04 | Comments and Responses – Coal Mine

SECTION 04 COMMENTS AND RESPONSES – COAL MINE	4-1
4.1 Public Respondents.....	4-1
4.1.1 Robyn Adams	4-1
4.1.1.1 Description of Project	4-1
4.1.1.2 Climate	4-1

Figure: 4-1

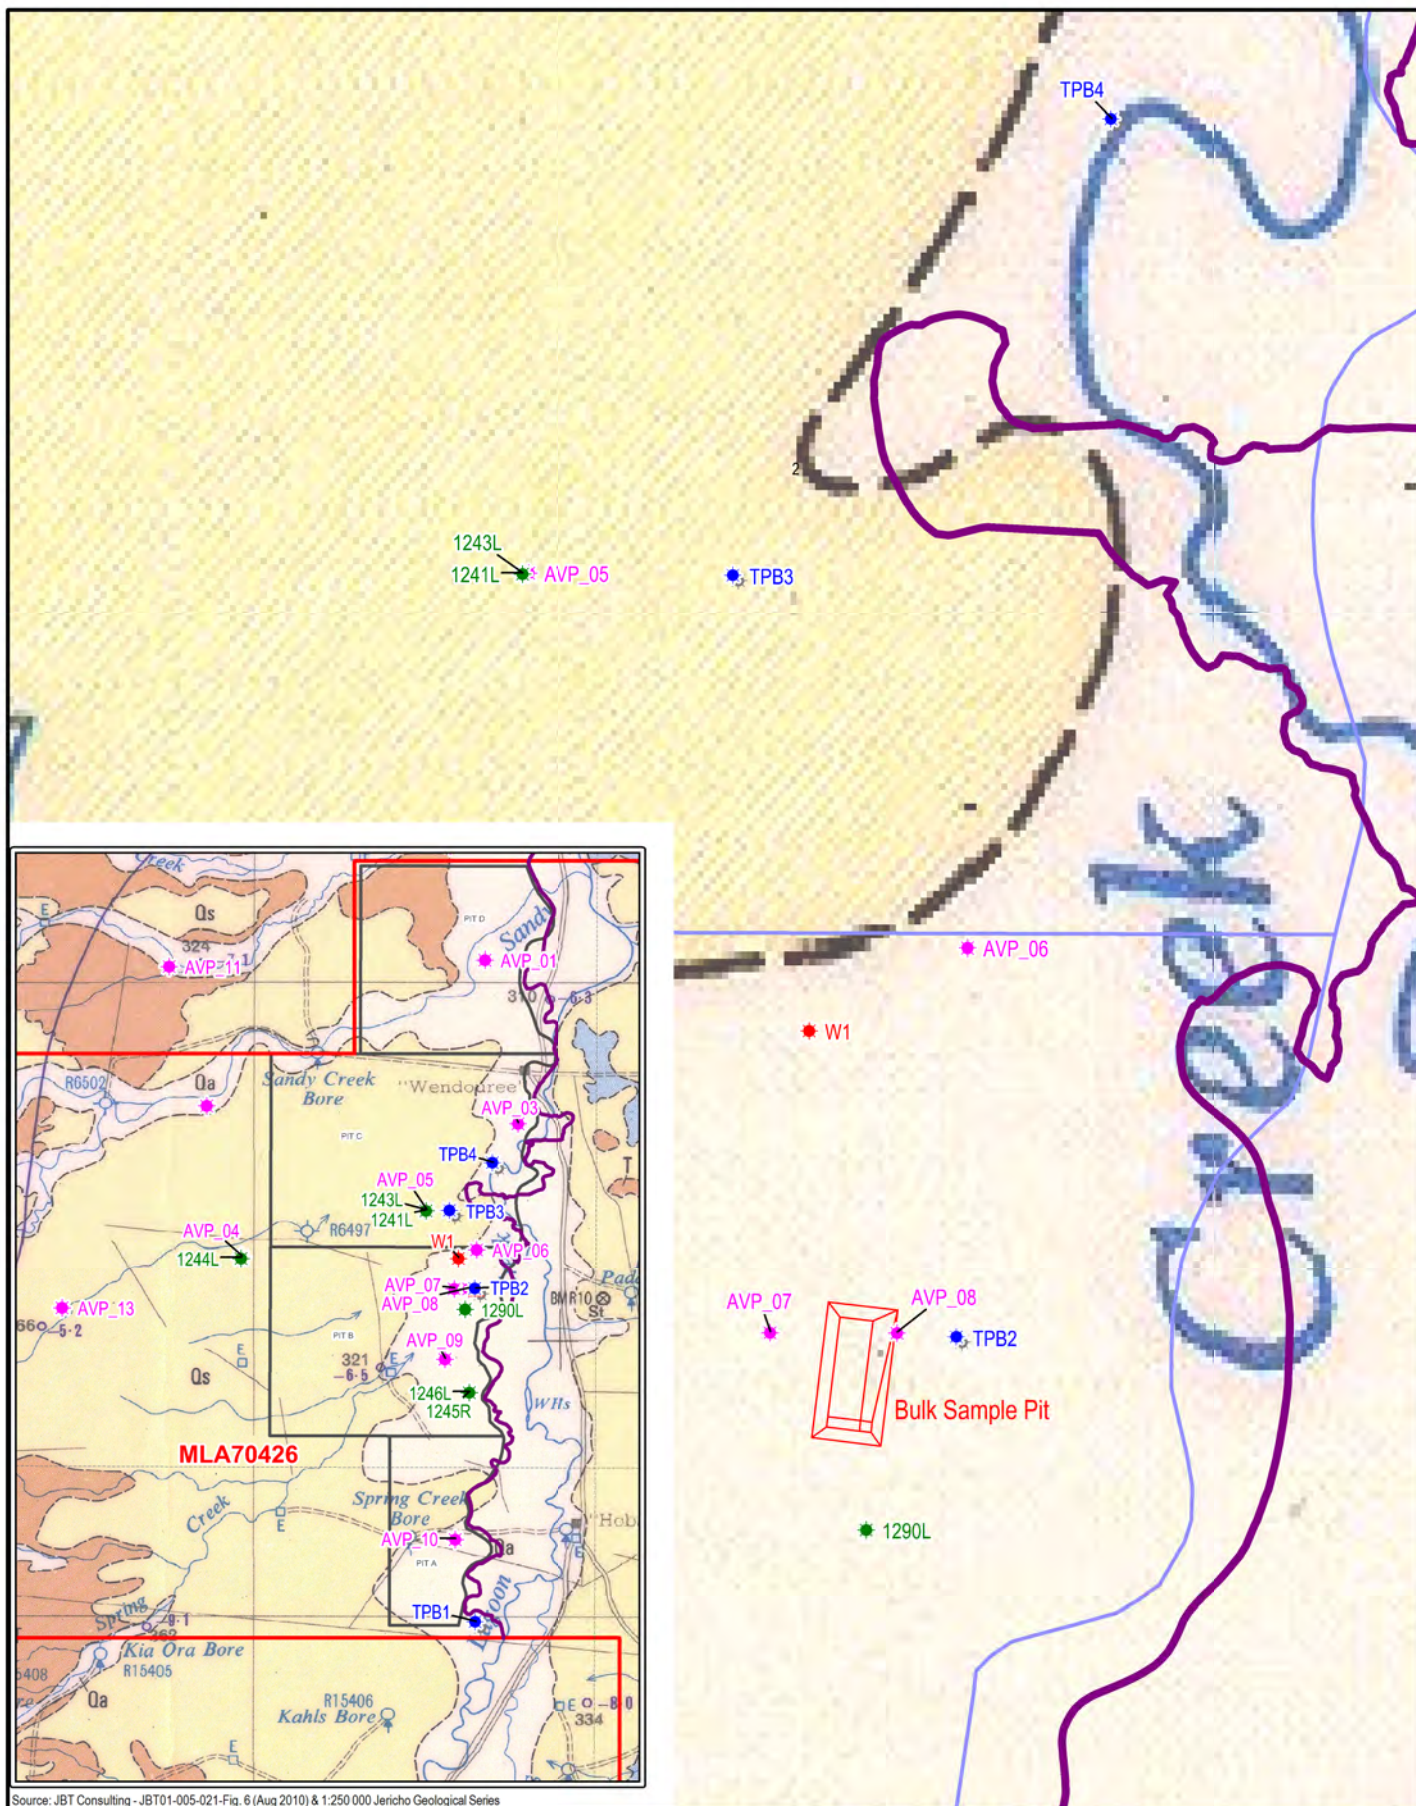
Comment – CM36

Further investigation including full groundwater modelling should be undertaken before the EIS is approved. To the best of my knowledge, no pump drawdown testing has been conducted by the Proponent. The study for PREDICTIONS not FACTS in the EIS by the Proponent have undertaken is relying on a short pump test completed 29 years ago by the previous owners of the exploration lease. In the predictions our bore water (which we rely on exclusively on for domestic water and much of our stock water) would be in the area of 100 metres of drawdown and as such we would be left with no water.

Site specific aquifer data was obtained during the dewatering, both in-pit and out-of-pit, of the Alpha bulk sample test pit. These data regarding bore yields, bore level change over time, and recovery allowed for the evaluation of large scale groundwater extraction (38 ML over 3.5 months) on the local groundwater resources. These data, presented in SEIS Volume 2 Appendix N, are utilised in constructing and calibrating the predictive groundwater model.

An additional pump test was conducted during February 2011. Bore 1290L was tested to determine aquifer hydraulic parameters within the test pit area (as indicated in Figure 4-1 below).

Figure: 4-2

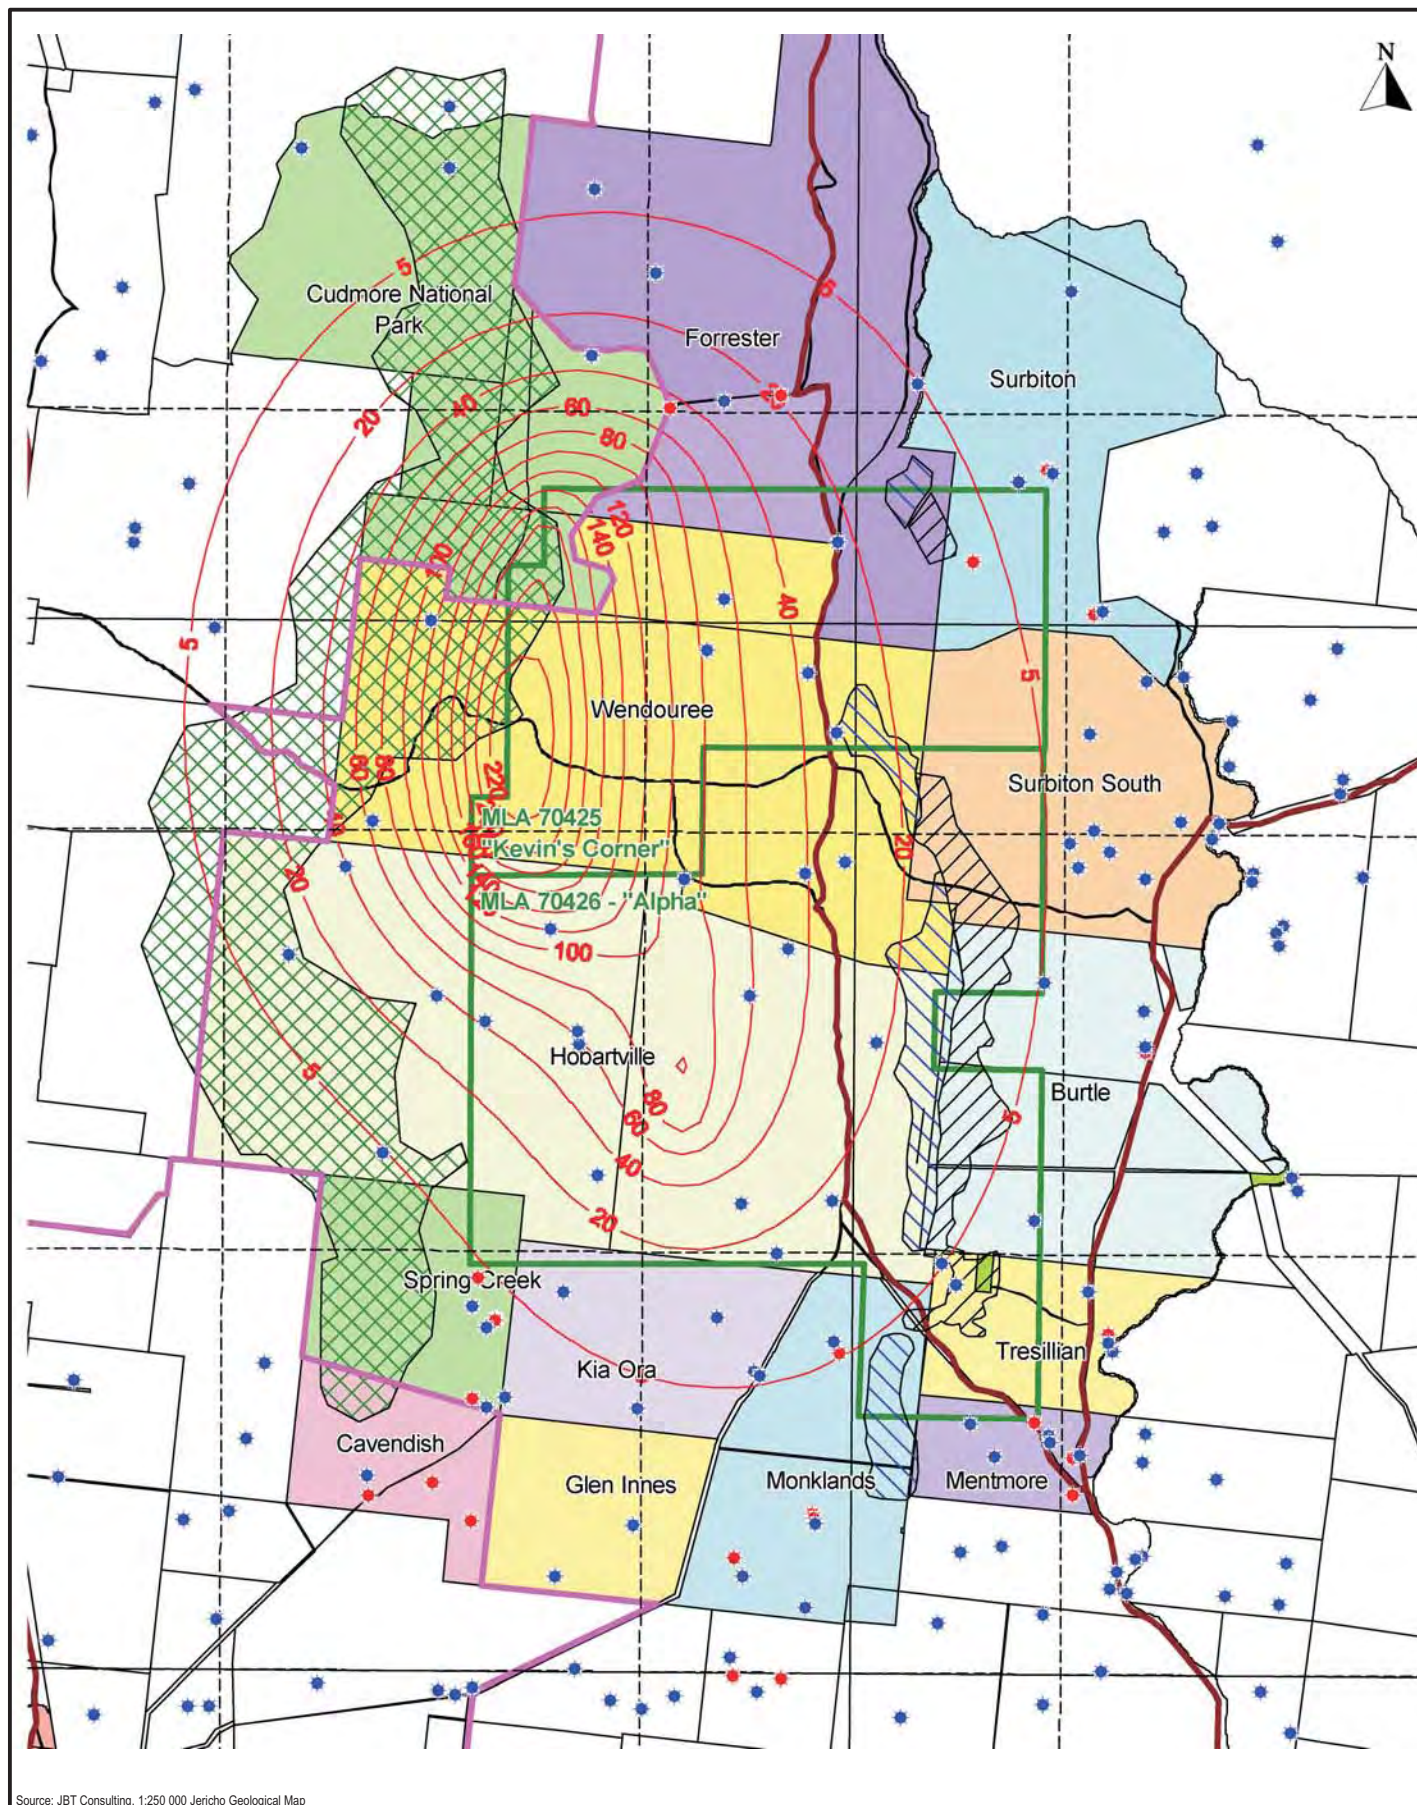
Comment – CM74

I would like some surety that the pit dewatering will not will not affect the water table.

EIS Volume 2 Section 12 details the envisaged impacts of mine dewatering on the local groundwater table. Preliminary dewatering impacts are included in EIS Volume 2 Section 12.9.5, which indicate that a reduction of groundwater levels, within the Colinlea Sandstone aquifers, of 5 m or more may occur up to 10 km from the open pit (Figure 4-2). This would occur when the confined sand aquifers are depressurised to allow “dry” stable mining conditions.

Interim predictive groundwater modelling (SEIS, Volume 2 Appendix N) has been used to reassess the possible impact of mine dewatering. The resultant predicted drawdown cones and recorded bores have been included on Figure 4-2. This indicates the neighbouring bores, which could potentially be impacted by dewatering over time.

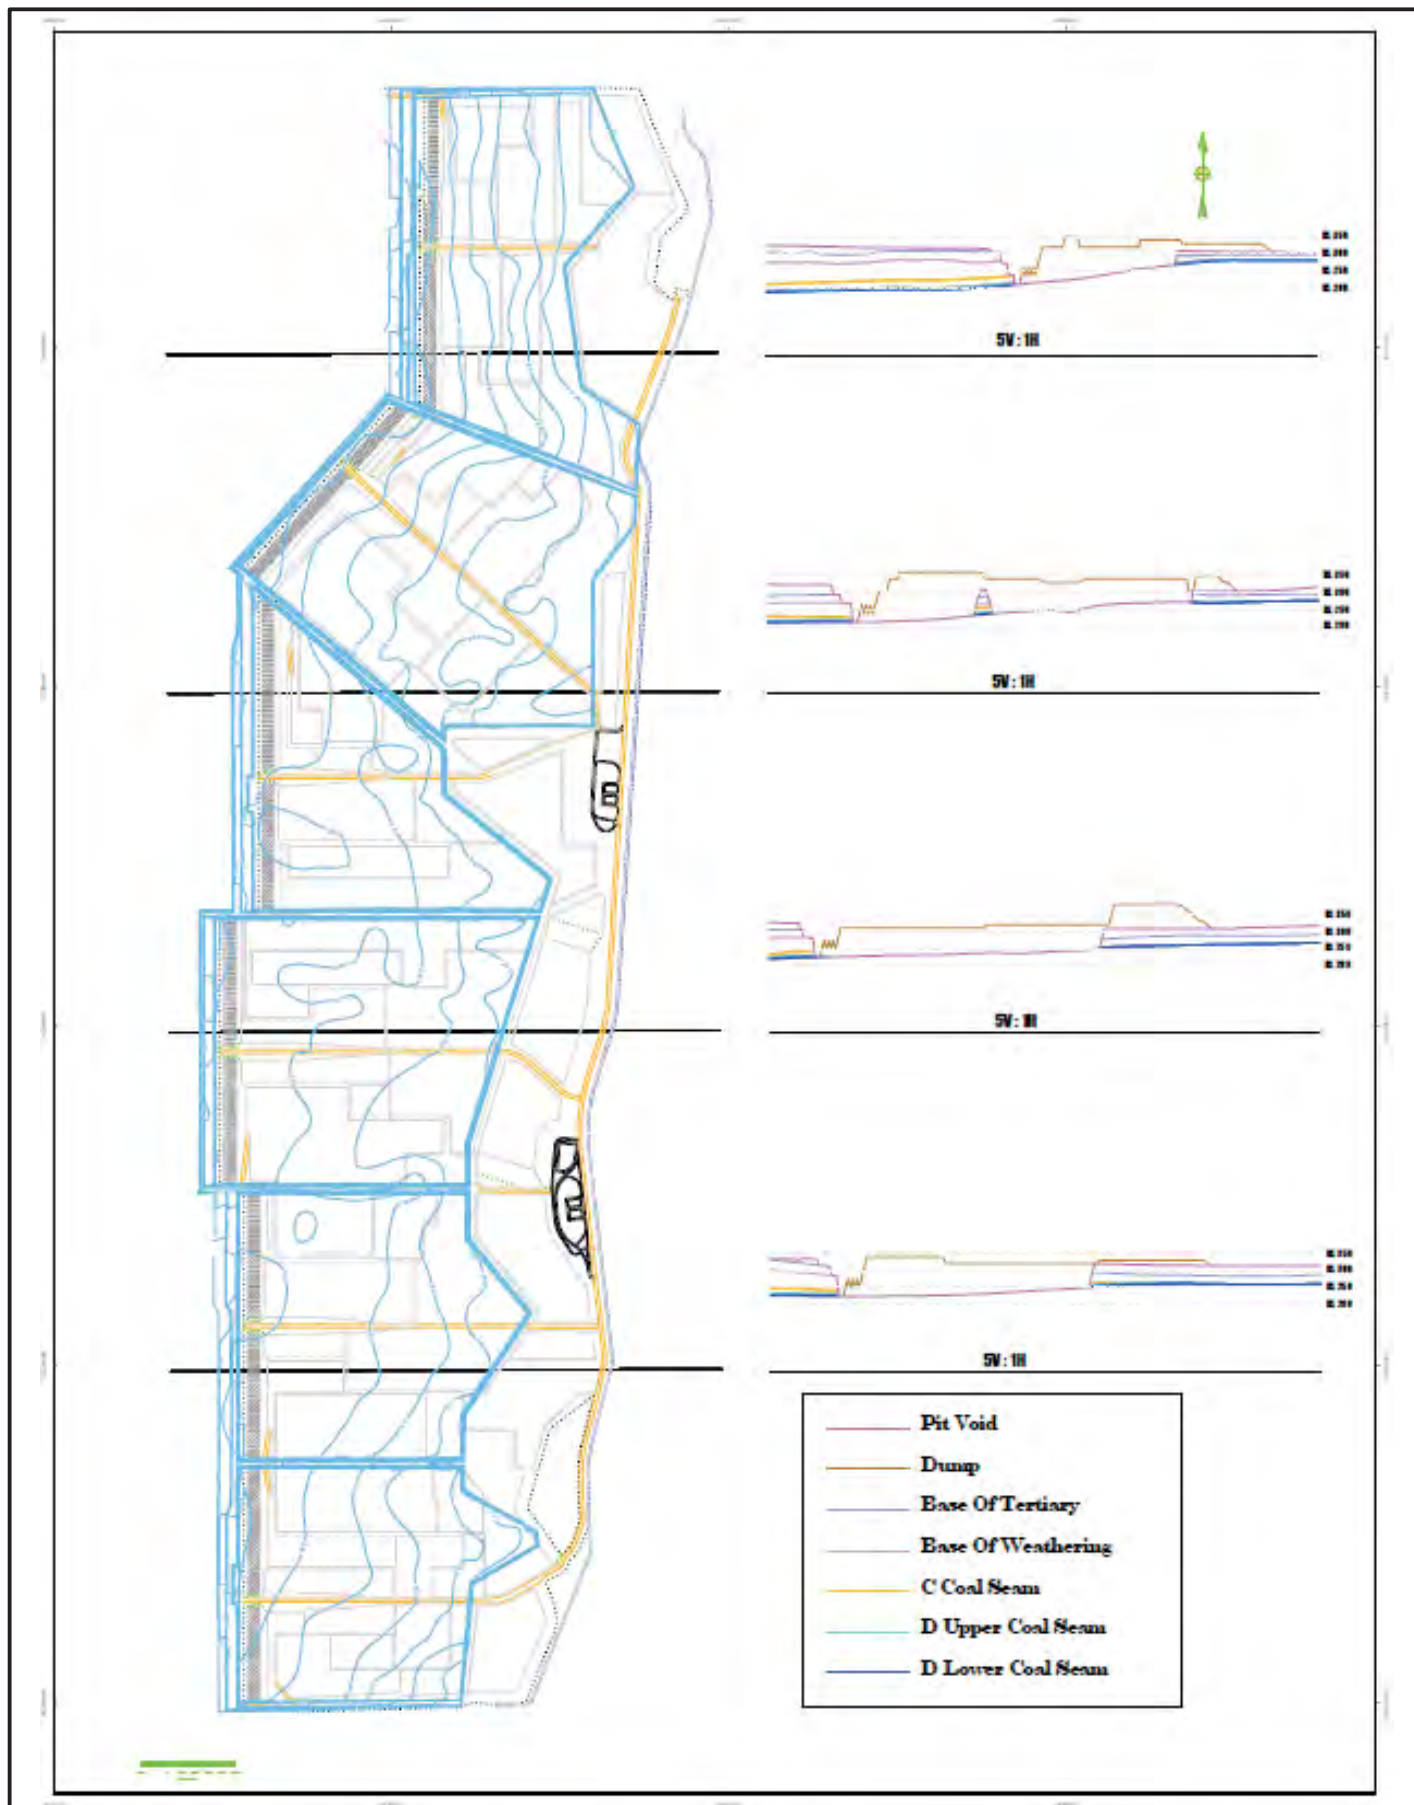
Comment – CM108

The geological stability throughout the life of the mine and post mining is required. A post mining rehabilitation and reinstatement plan is requested by Barcaldine Regional Council due to the high level risks of slope instability, potential for spontaneous combustion and alteration to the aquifers and groundwater table to understand the final mine landform, potential uses and reinstatement of environment, water sources and infrastructure.

The envisaged final land form is included in Figure 4-3 below. The final void walls have been benched to ensure stability.

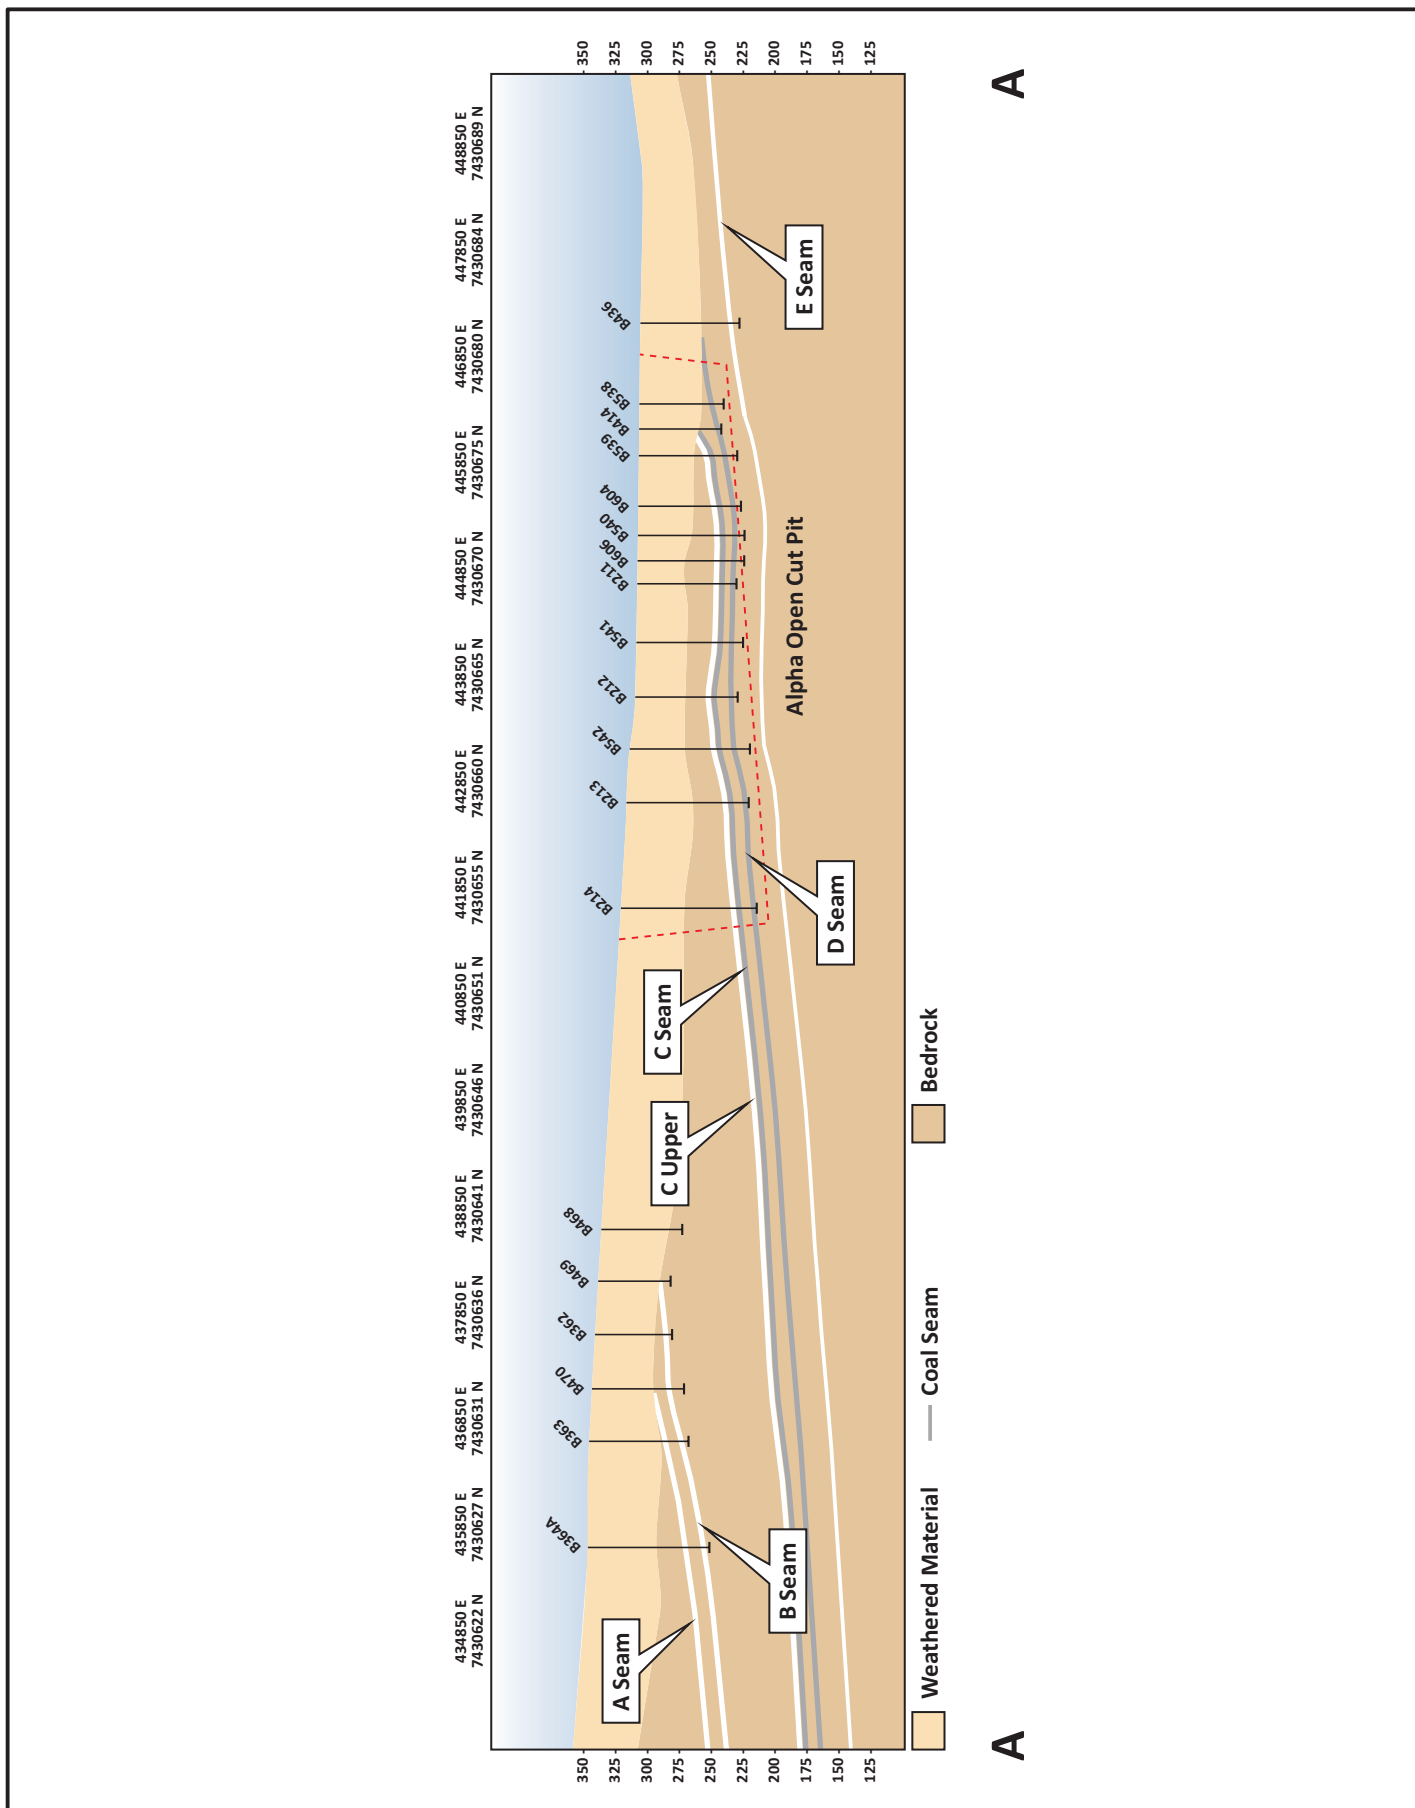
Comment – CM222

Geology generally well done although it is noted that the description of the geology in the text does not match the section in Figure 16.5 in that there are no Tertiary or Quaternary sediments shown in the section.

EIS Volume 2, Section 16.3.2 regarding waste refers to a cross section and not the lithostratigraphic column presented in Figure 16.5. The cross section referred to is Figure 4-3 in the Geology Chapter (EIS Volume 2, Chapter 4).

The cross section presents the Cainozoic sediments as weathered material, due to the lack of core through this weathered horizon. Plate 4-1 of the Geology Chapter (EIS Volume 2, Chapter 4) provides a picture of the drill chip returns (percussion drilling) through the Tertiary and Quaternary sediments. The latest cross section is provided below in Figure 4-6.
